**TO** The City of Newcastle Council

**LOCATION** 11 - 17 Mosbri Crescent, The Hill 2300

**SUBJECT** Compensatory planting species list

**DATE** 24 November 2021

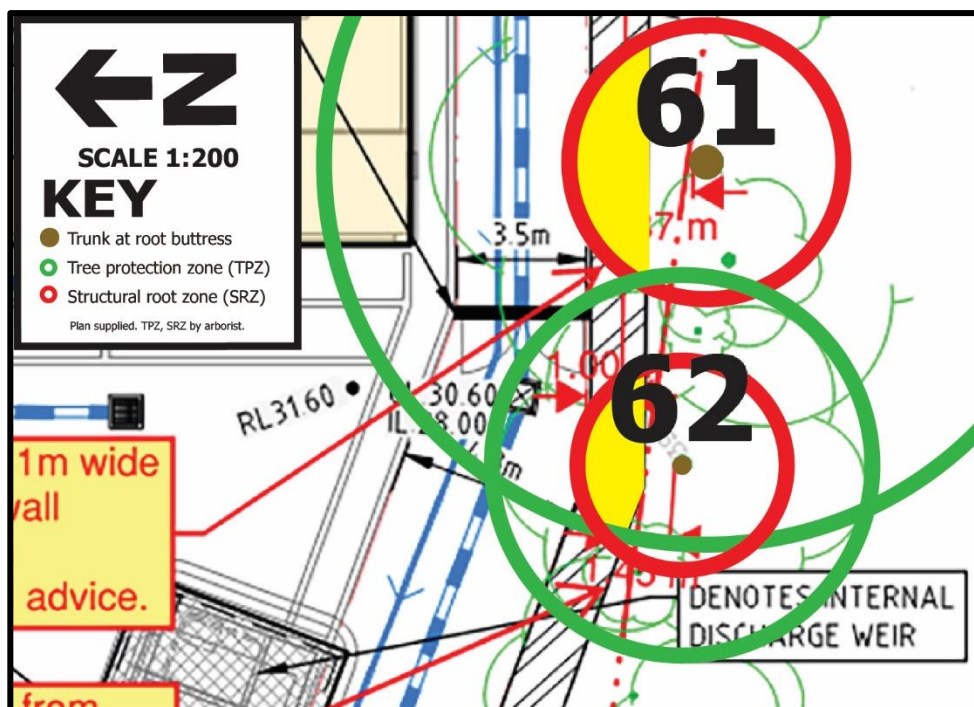
- 1.1. It has been requested that I review the position of a proposed shoring wall of 11-17 Mosbri Crescent, The Hill in relation to its affect to two trees in the adjoining site of 13 Hillview Crescent, The Hill. These are shown in the below photograph taken from the location of the proposed shoring wall.

- 1.2. These two trees are retainable and will require implementation of specific tree protection measures as discussed herein.
- 1.3. The following information aligns with *AS 4970-2009 Protection of Trees on Development Sites* in quantifying the situation these two trees would experience.
- 1.4. I have also included a table of those trees to be retained and those to be removed.
